HISTORIC AREA STATEMENT UPDATE CODE AMENDMENT

Engagement Report

September 2025

Figure 5: Real estate sketch of Palmer Place frontage of Subject Property, late 1980s.

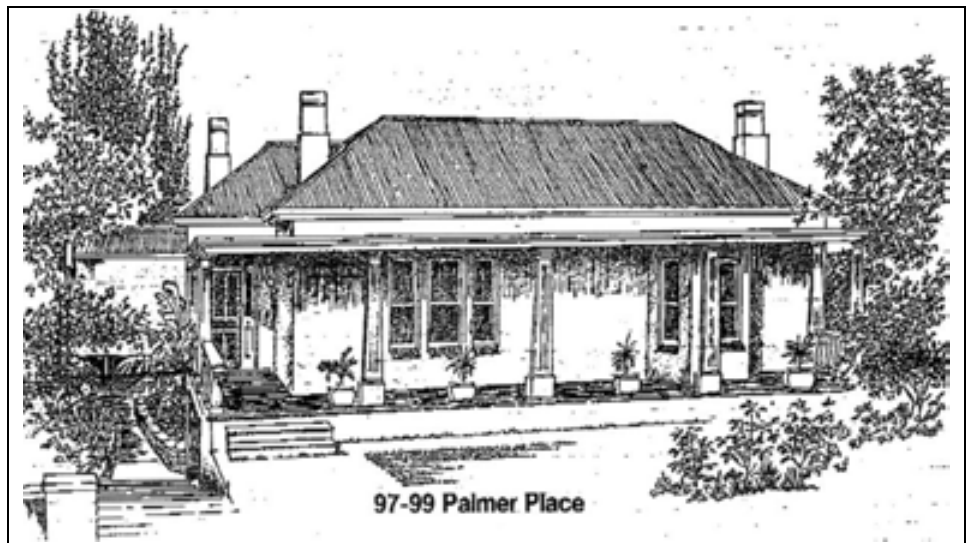
While only a sketch, this image clearly illustrates the original modest asymmetric form of the dwelling as it presents to Palmer Place. Despite the verandah detailing being clearly not original (dating possibly c1940-1950), its form, returning to the northern side, likely is. This sketch also shows the original entrance setback off the return verandah to the northern (left) side and single bay window to the right.

Even in the circumstance where reconstruction might be contemplated, there appears to be no specific details of what the building's original style was in order to facilitate this. The only current located image of the Palmer Place frontage is a c1980s real estate sketch (Figure 5). While this sketch shows the original form and configuration of the building, it lacks any illustration of the original 1880s architectural detail that heavily characterised development of this era. This is particularly the case for the verandah that is clearly not original (c1940 - 1950s).

has been reconstructed to a different layout in either salvaged or newly sourced material, so lacks any integrity to the original era of construction. Accordingly, there is no basis for the inclusion of 99 Palmer Place as a Representative Building. These findings remain consistent with two prior reviews undertaken by the Administration in 1993 and 2005, which saw any pursuit of a Local Heritage listing rejected. The Code does provide limited circumstances, however, where demolition is contemplated, namely: Performance Outcome 7.1 notes: <i>Buildings and structures, or features thereof, that demonstrate the historic characteristics as expressed in the Historic Area Statement are not demolished, unless</i> (a) <i>The front elevation of the building has been substantially altered and cannot be reasonably restored in a manner consistent with the BUILDING'S original style</i> (b) The structural integrity or safe condition of the original building is beyond reasonable While PO7.1(b) would clearly not be satisfied for the subject property, the extent of alteration undertaken in the 1980's would almost certainly stratify (a). The scale and extent of alterations were extensive and included the demolition and reconstruction of the majority of the façade to a different form, scale and style. The extent of alteration is so great that it <i>cannot be reasonably restored in a manner consistent with the buildings</i>	The building presents to the street as an intact symmetrical Victorian House however this is not the case. The presentation to the street is the result of mixed eras of construction. 99 Palmer Place presents with Victorian characteristics that are also present in the streetscape however the integrity is low as the characteristic elements have been applied to an earlier building of a different style. The symmetrical façade to 99 Palmer Place is the result of major alterations which occurred in 1987. These works completely altered the configuration and style of the building. The current house represents a building which is grander than the original. Designation as a Representative Building is not appropriate as this would misrepresent the historic development pattern of the area. Listing a 1980s reproductive style would misrepresent the historic development pattern of the Area. <u>Recommendation</u> - Not recommended for inclusion as a Representative Building Objection supported.

Figure 6: 1987 architect's documents showing ground floor demolition plan, showing retained walls in red

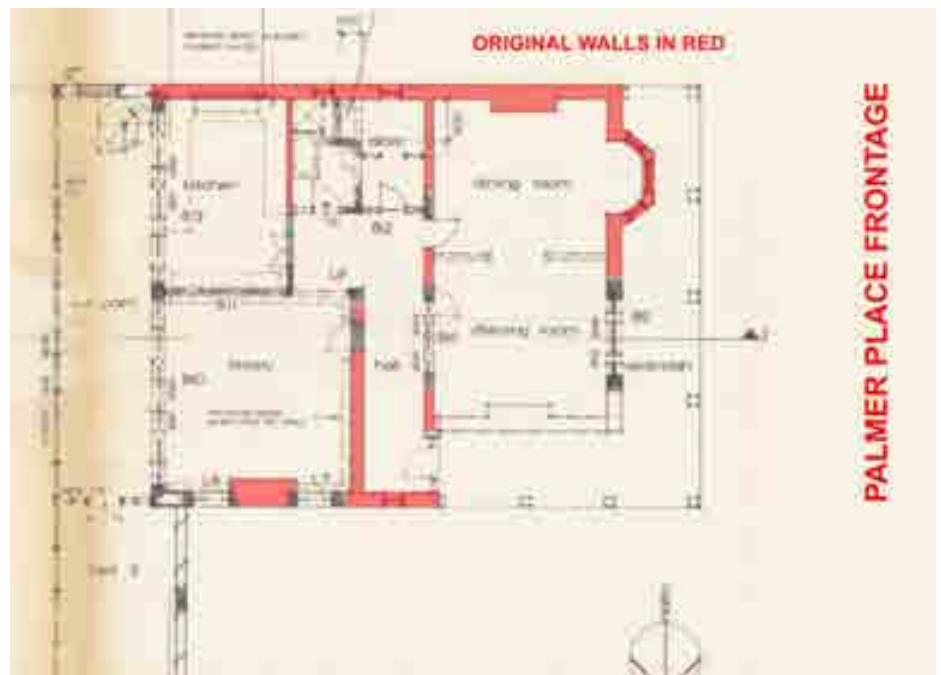
The extensive nature of these renovations also extended to the lower ground level, building interiors and the rear (eastern) elevation, all of which were notably expanded and reconfigured.
